Product Change Notification: P-22-022148

Action pin for 1mm hole only support Asia-pacific market.

# Explanation for a duplication production tool 11-1958975 for Action pin for 1mm hole

New die:11-1958975,Mark

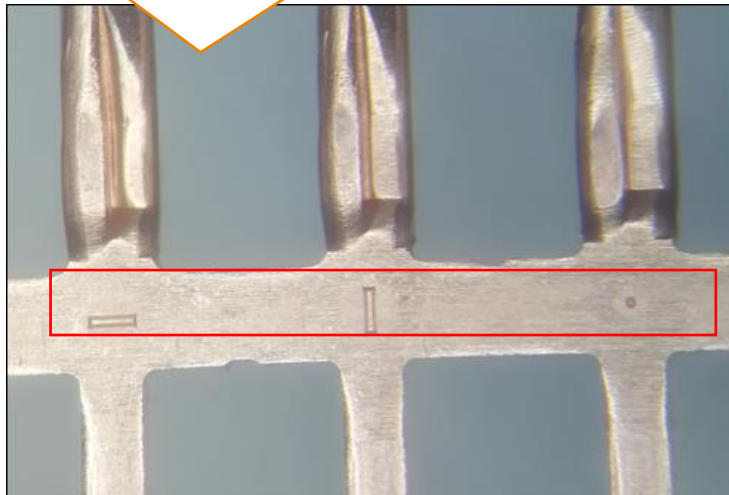
1. For China local customer requirement Action pin for 1mm hole, the copy duplication production tool (11-1958975 ) in TE Suzhou plant for production to support only Asia-Pacific market. For this new duplication production tool , it will shorten the L/T of delivery time and offer good service for Asia-Pacific market
2. The identification of Suzhou production part is that there are die – identification marked “-” “|”“.” as below, **it is on the strip .**
